Solicitation Description: Addendum No. 1 EOI: Third Party
Peer Review Building Four

The State of West Virginia Department of Administration, General Services Division (the Agency) requires the services of a qualified engineering firm to provide third-party peer review services of major renovations to State Capitol Complex Building Four. Mueller Associates has more than five decades of experience providing engineering solutions and peer reviews on similar projects. We excel in the complex renovation of historical buildings, understanding how to protect significant structures while incorporating modern, efficient systems that minimize maintenance and operating costs while prolonging the life of the building.

PEER REVIEW, MECHANICAL, ELECTRICAL, AND PLUMBING, KINGDOM FELLOWSHIP, AME
CHURCH IN BELTSVILLE, MD

Fig 9: Corroded Fan Coil Unit at Bridge

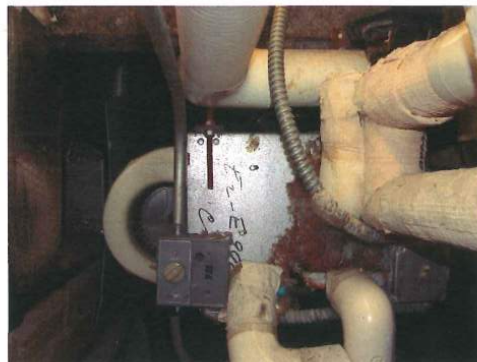
- The HVAC System Assessment report recommends replacement of fan coil units serving the 2nd and 4th floor bridges. We concur with this recommendation; the units were observed to be in poor condition during our site visit.

M1.3

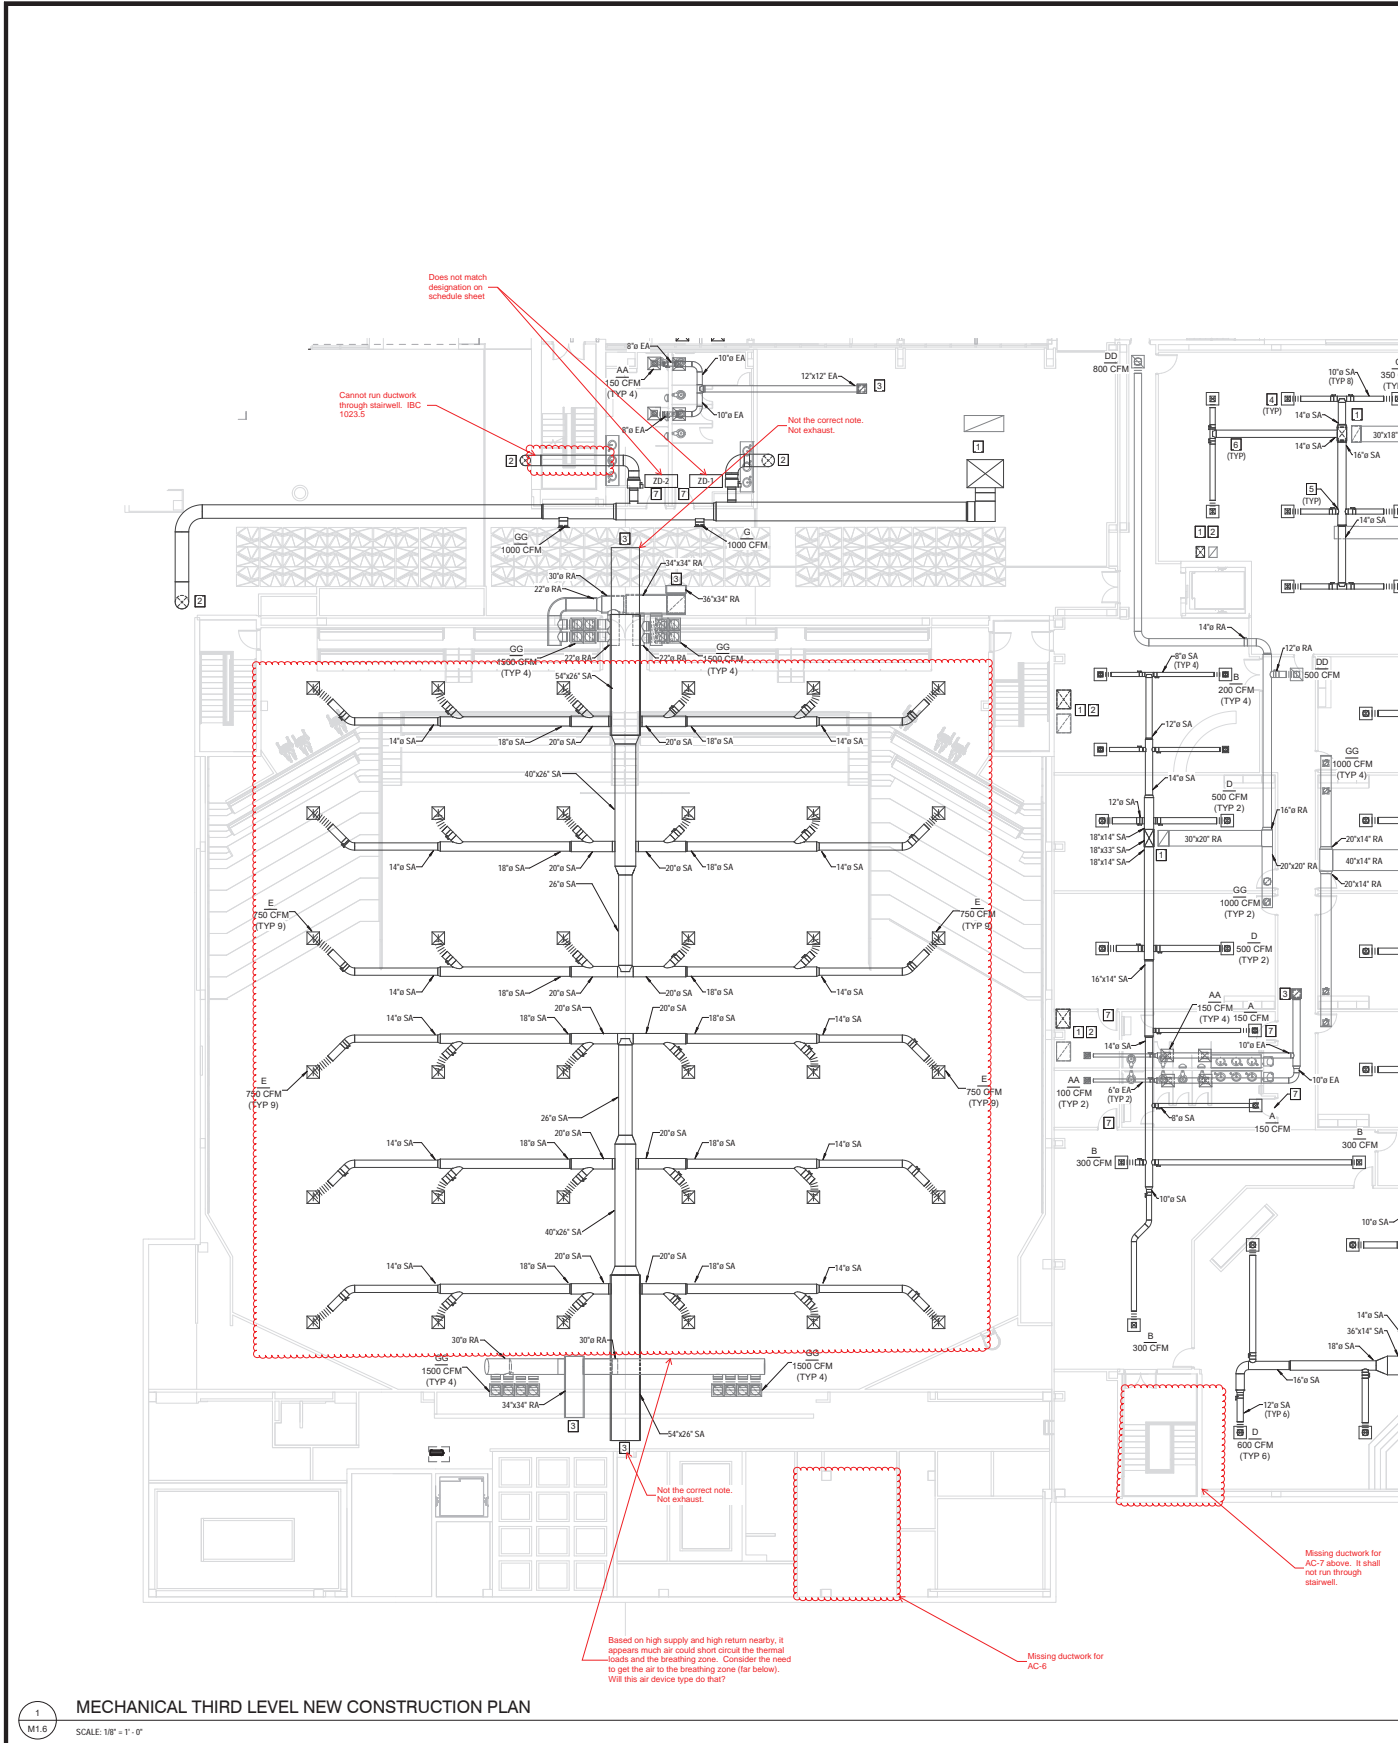
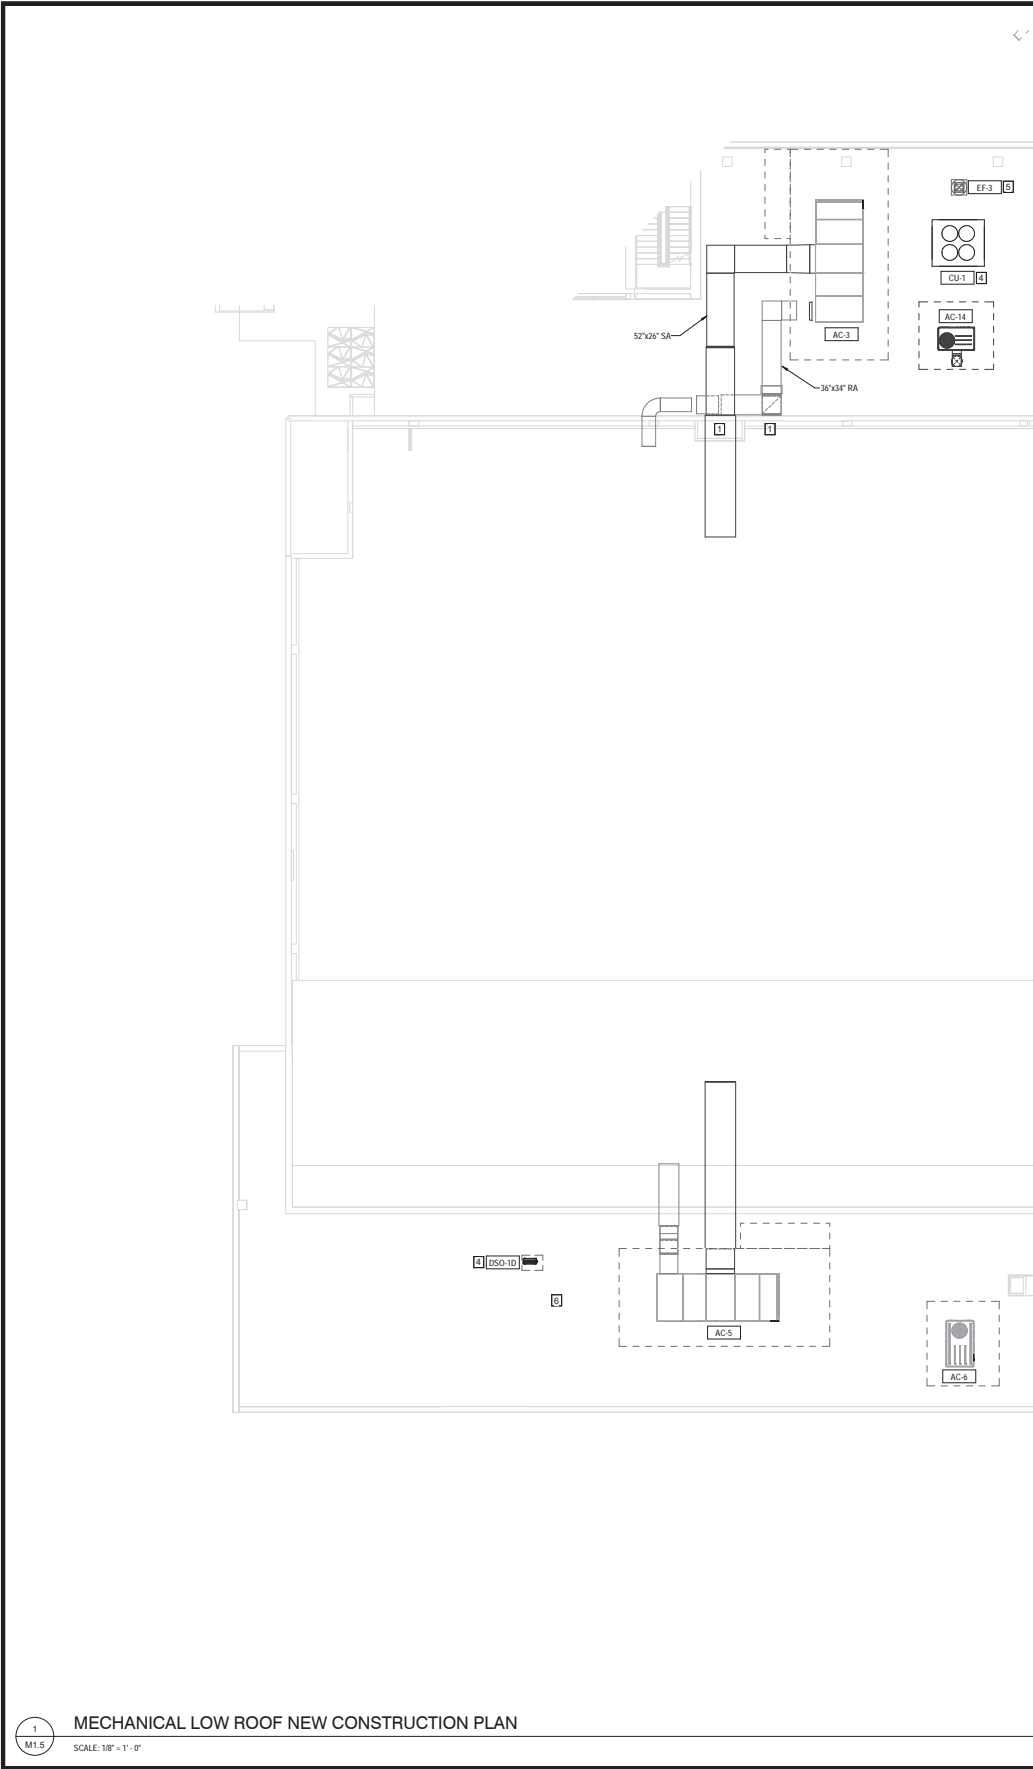
No atrium smoke exhaust system is shown.

No fire dampers, combination fire/smoke dampers, or fire rated shafts for ducts are shown. Ducts appear to penetrate multiple floors, thereby requiring fire rated shafts/enclosures.

Provide guards or fall protection where required by proximity to roof edge. IMC 2015 304.11

Show AC condensate piping. Define discharge locations.

Show refrigerant piping.

VARIABLE VOLUME AC UNIT CONTROL DIAGRAM (AC - 1)
SCALE: NONE

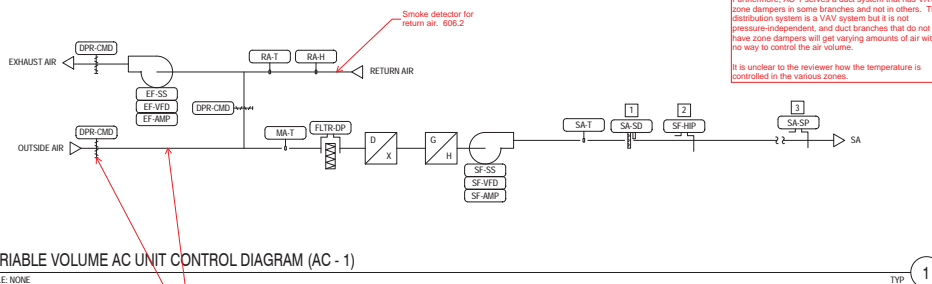
There are no controls shown for Zone Dampers ZD-101 and ZD-102.

There is also a VAV box control diagram on M8.1. If both diagrams are required, define where each one applies. If only one is required, delete the other one.
